ADDENDUM | No. 2

PROJECT	WEB Water Treatment Plant Improvements - 2022
BID DATE	1:00 PM Central Time Zone September 12, 2022
BID LOCATION	WEB Water Office 38456 W US Hwy 12 Aberdeen, SD 57401
ISSUE DATE	September 8, 2022
NOTICE	Failure to acknowledge all addenda in the BID may cause rejection of the BID. See Instructions to Bidders.

Sheet 2-15.3

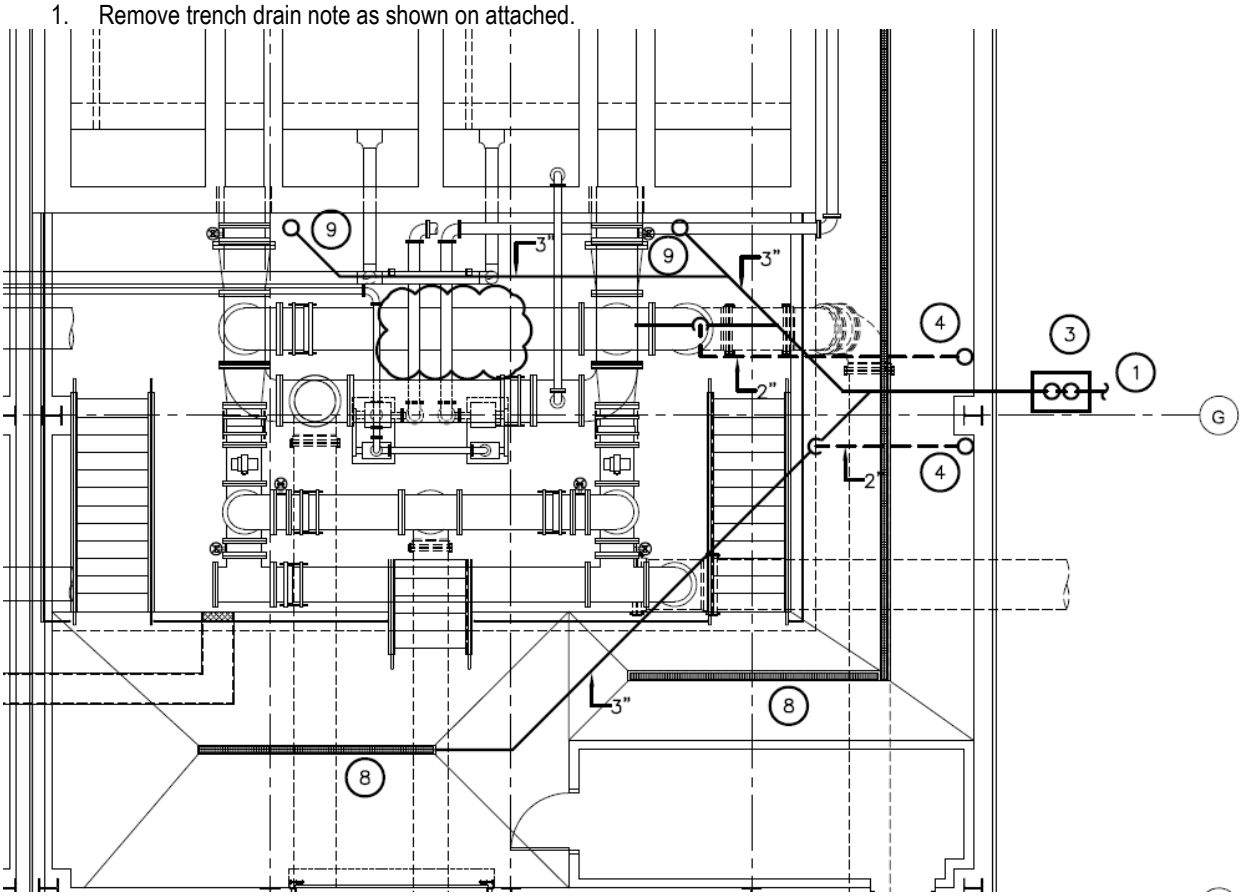
1. Remove trench drain note as shown on attached.

PROFILE - 36" TW LINE

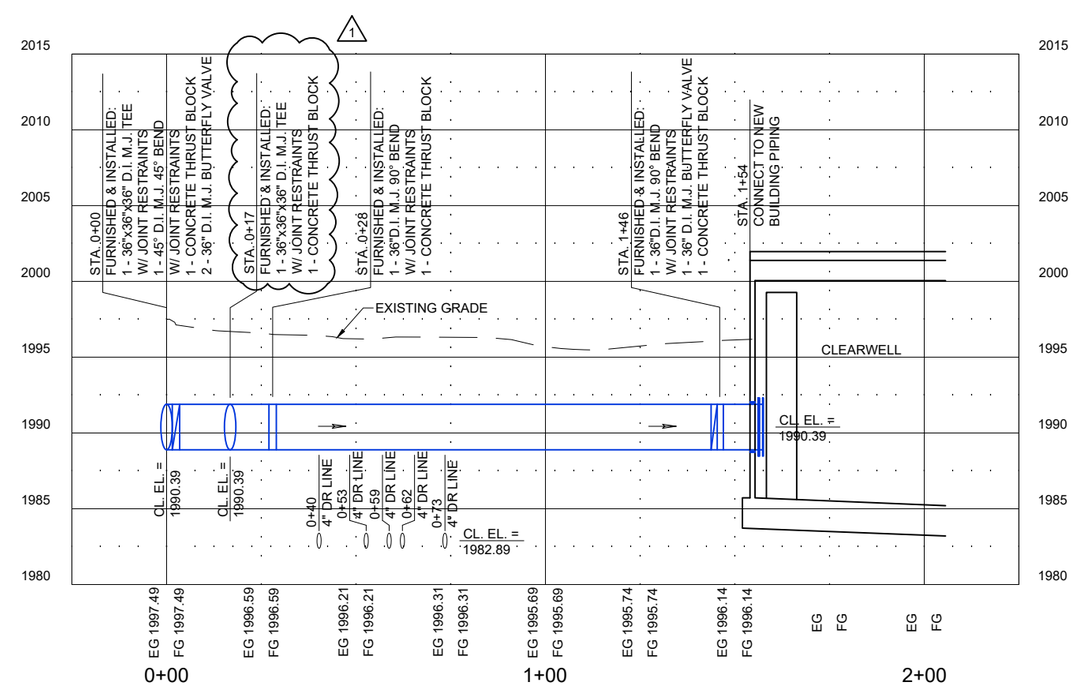
Revised PROFILE – 36" TW LINE profile and profile notes. Removal of 1 – 36" D.I. M.J. Butterfly Valve.

PROFILE - 24" WR LINE

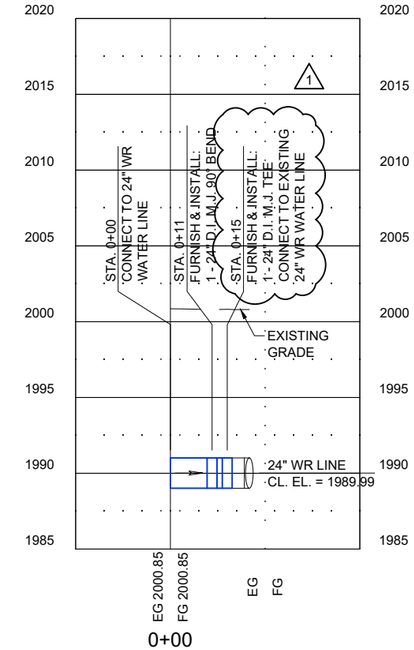
Revised PROFILE – 24" WR LINE. Removal of 1 – 24" D.I. M.J. Tee.

SHEET No.:
2-2.3

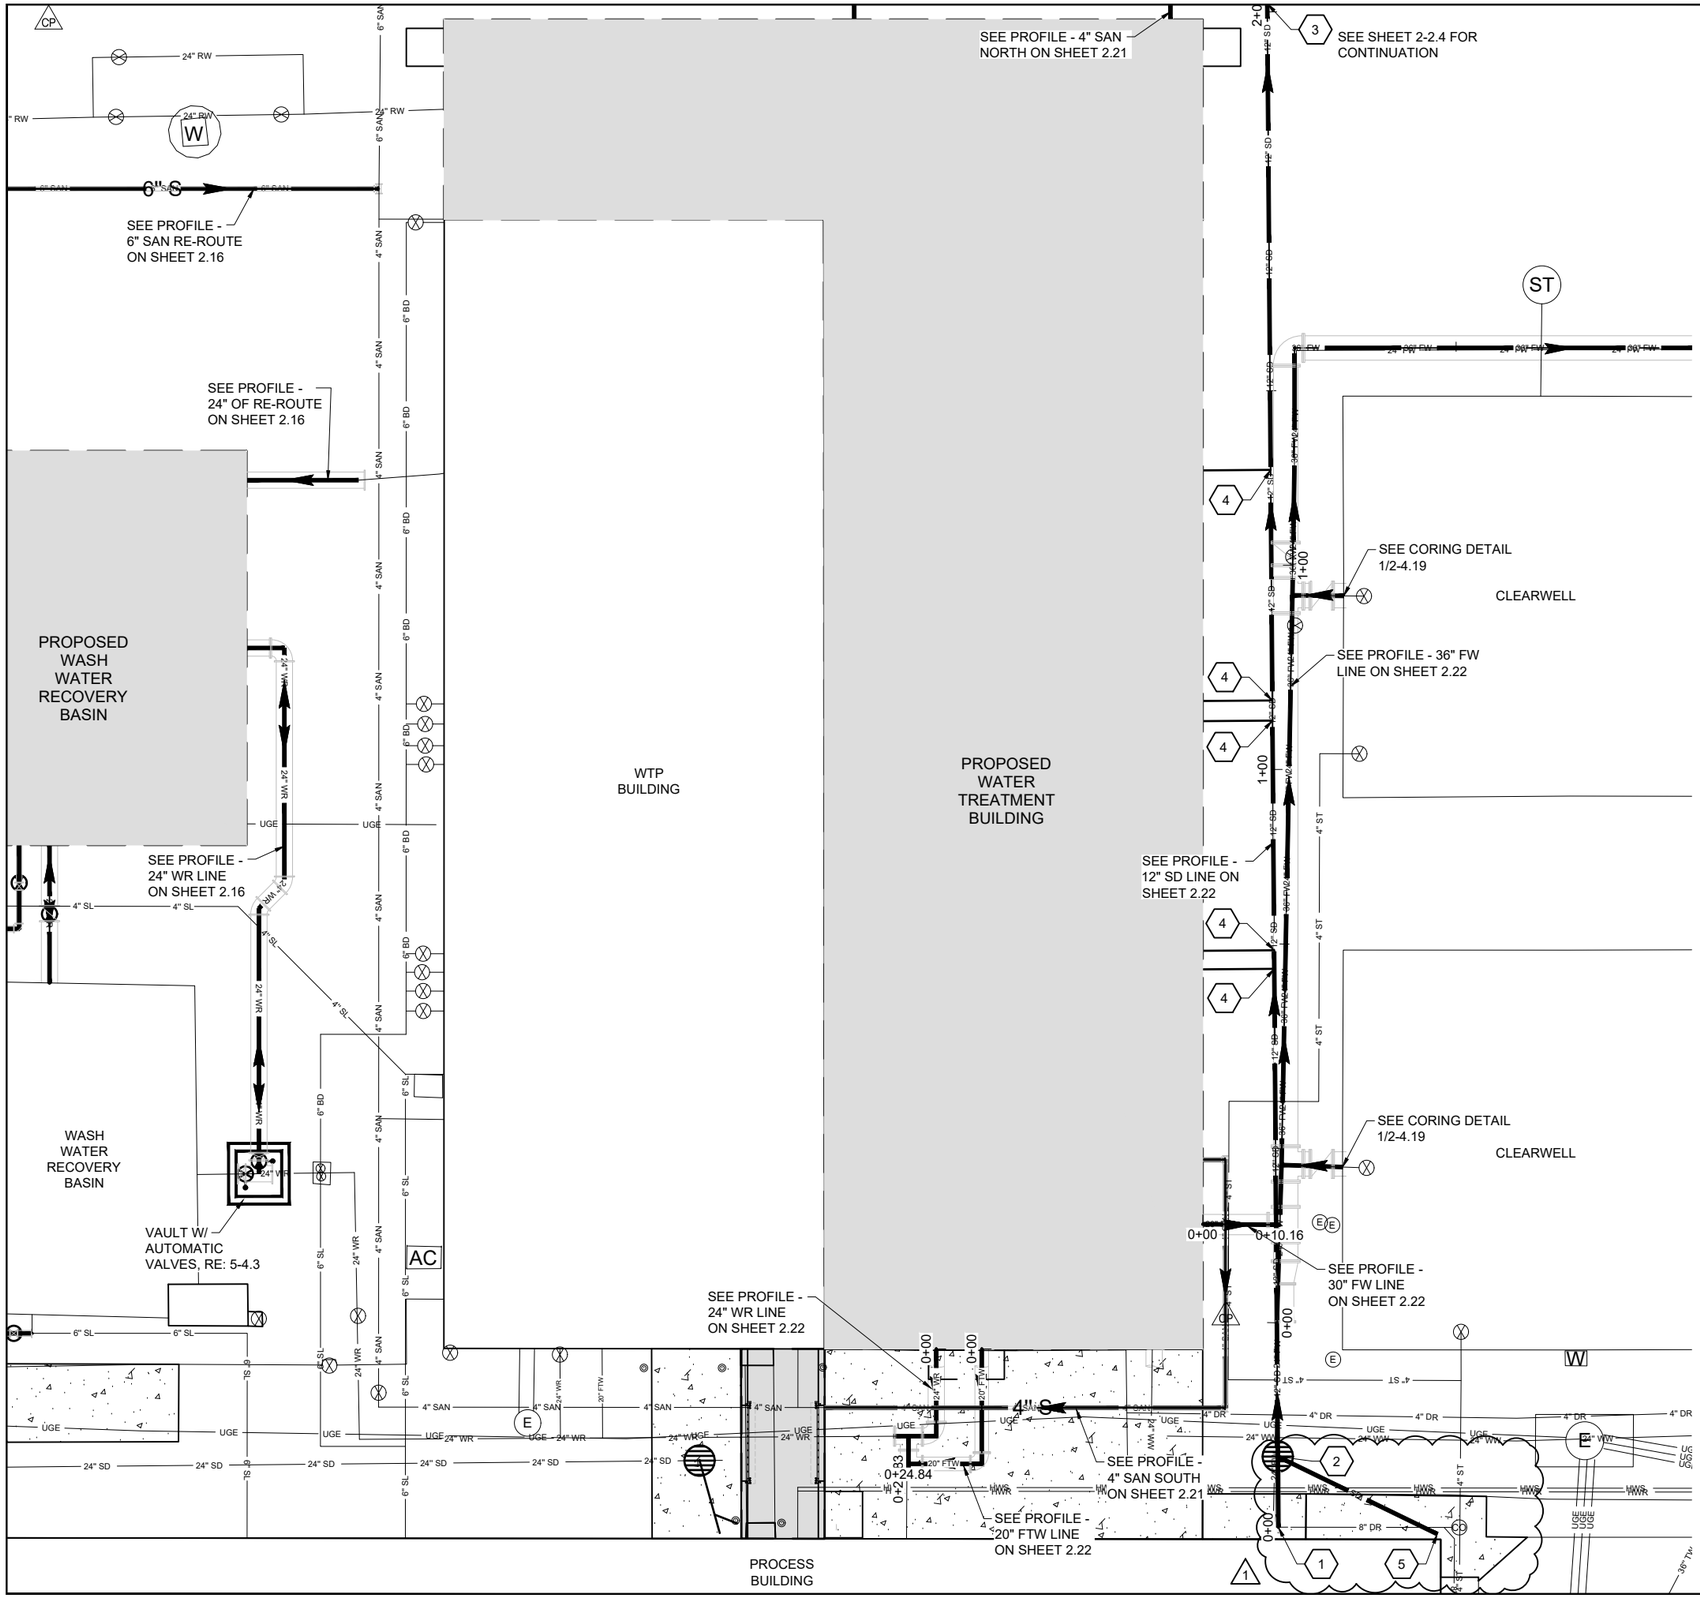
Revised Storm Sewer Keynotes

SHEET No. :
2-2.4

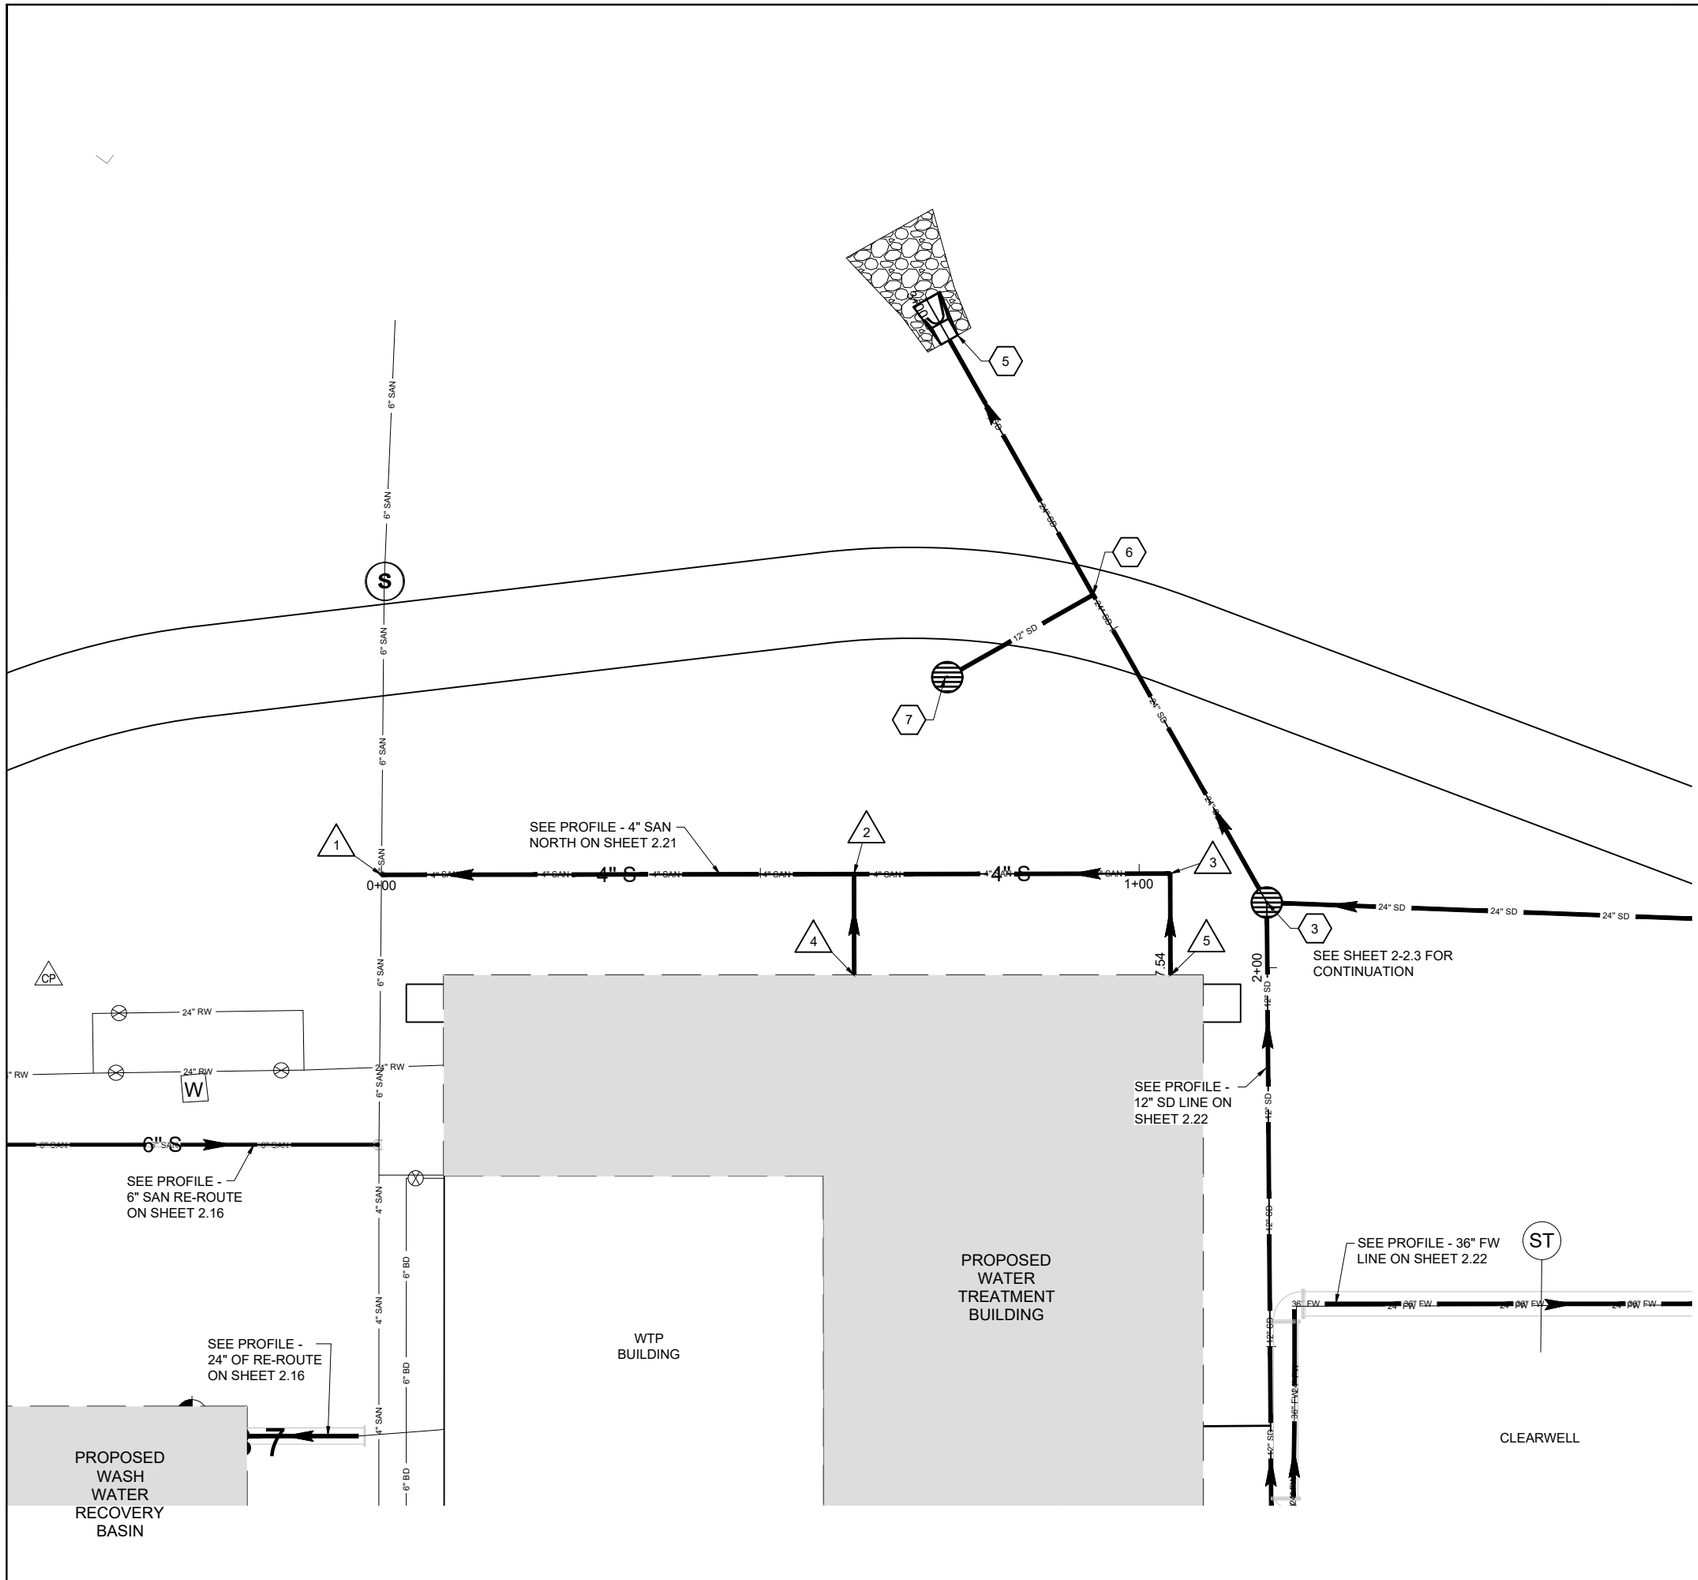
Revised Storm Sewer Keynotes

LOWER LEVEL PIPING PLAN

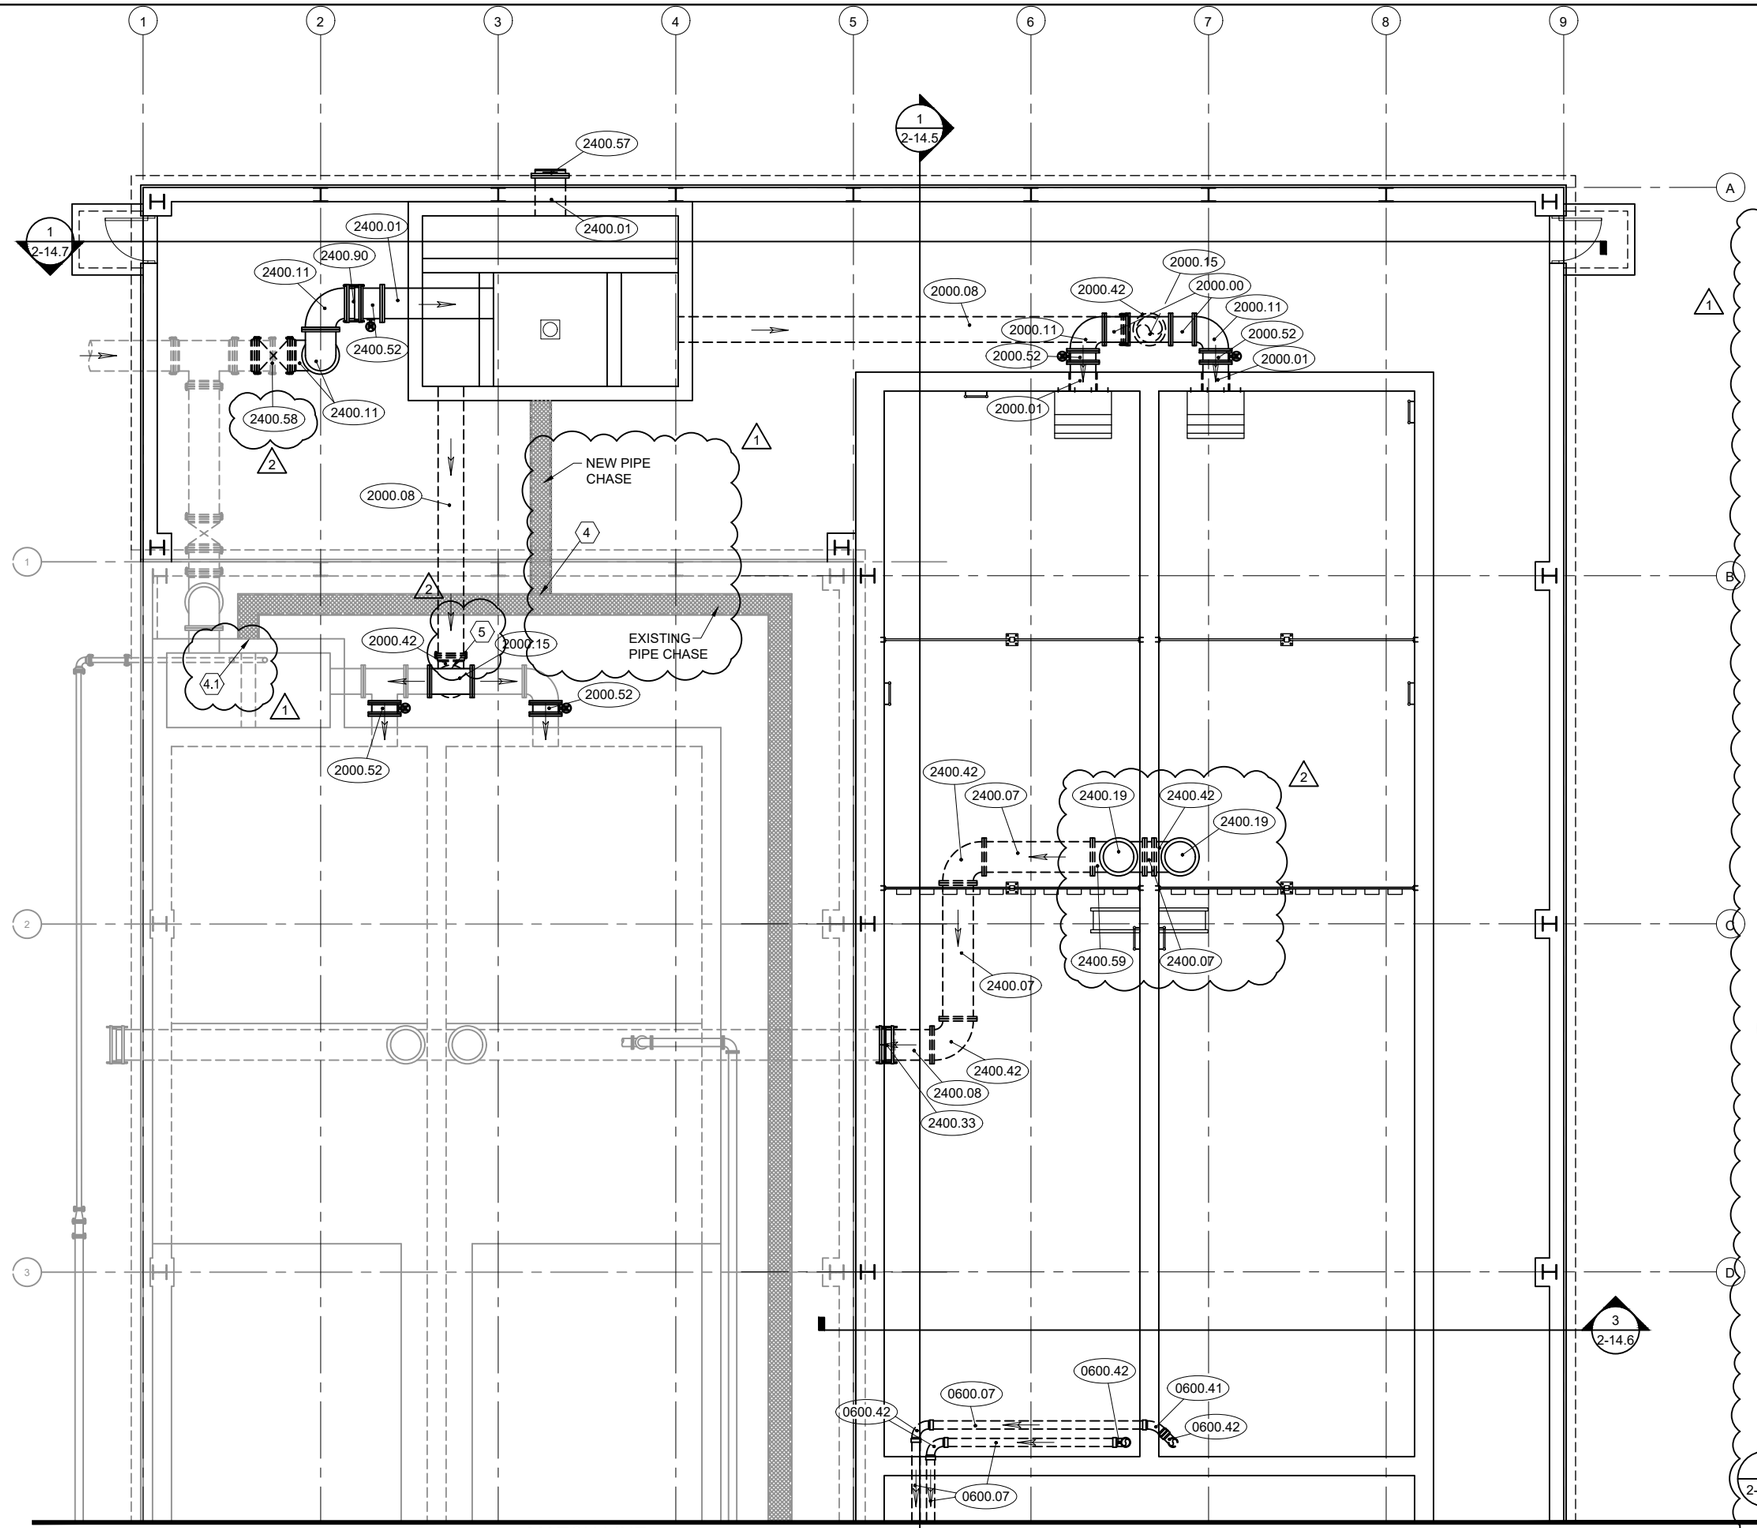
Revised piping tags. Added Note 5. Revisions on Sheet 2-14.1 shall also apply to Sheet 2-14.3 and Sheet 2-14.7.

5. NEW PIPING SHALL INCLUDE VERTICAL PIPE SPOOL (2000.02) BETWEEN 90° BEND (2000.42) AND TEE (2000.15). CONTRACTOR SHALL FIELD VERIFY REQUIRED LENGTH OF VERTICAL PIPE SPOOL.
